**PLANNING COMMISSION  
STAFF REPORT**

AGENDA ITEM: Planning File No. **MAJ-23-0011**, a Major Site Plan application for a new mixed-use/affordable housing development and **REZ-23-0002** a Rezoning application for a Planned Unit Development (PUD) located at 101 West Main Street.

LOCATION: 101 W Main Street / LOT B-1 WEST FRISCO 70 SUB # 2

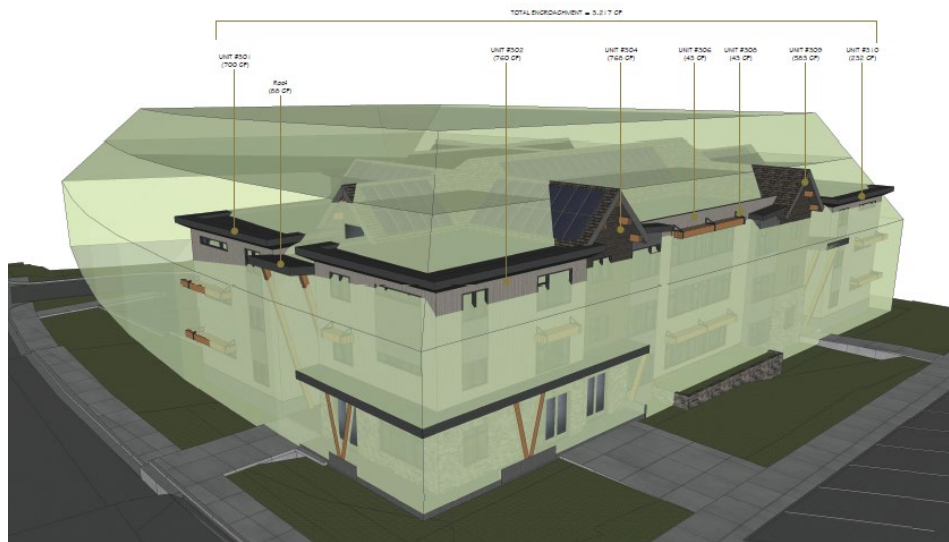
**Refuse Management** (§180-6.17): All commercial, mixed-use and multi-family residential development projects containing five (5) or more units shall utilize dumpster enclosures for the storage of all refuse, recycling, grease traps, and compost collection. The application materials note a proposed location for the dumpster and recyclable materials but do not provide details on the design. The proposed refuse and recycling facilities must be located within an enclosure with walls and a roof. The enclosure must also be wildlife proof.

The applicant will be required to submit a letter from a waste disposal company showing that the proposed refuse and recycling facilities are located and sized appropriately for the proposed project. The dumpster enclosure will be reviewed for full compliance at the time of the final review of the Major Site Plan application.
